### MEMORANDUM

To: Development Review Board  
From: Mary O'Neil, AICP, Principal Planner  
Date: April 18, 2017  
RE: ZP17-0762CA/CU; 35 Grove Street

**Request:** Addition to existing single family dwelling, demolish garage, construct detached accessory dwelling unit, reconfigure parking area.

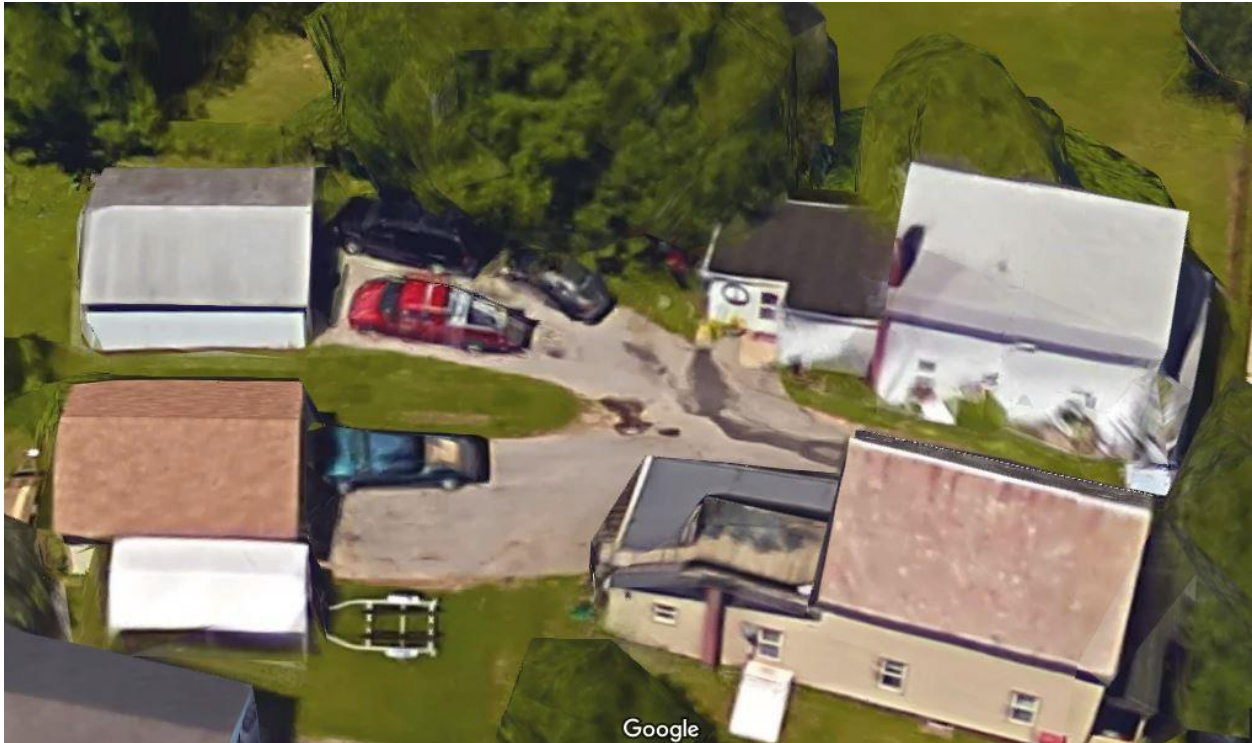
*2. The unit does not consist of more than 30 percent of the total habitable floor area of the building, inclusive of the accessory dwelling unit;*

Utilizing the definition of habitable space from Article 13, the ADU does not exceed 30% of the total habitable floor area of the principle dwelling and the ADU combined. **Affirmative finding.**

6. The accessory dwelling unit is limited to 30% of the habitable area of the single family residence including the ADU. As proposed, the ADU may not expand into the proposed area defined as a workshop.
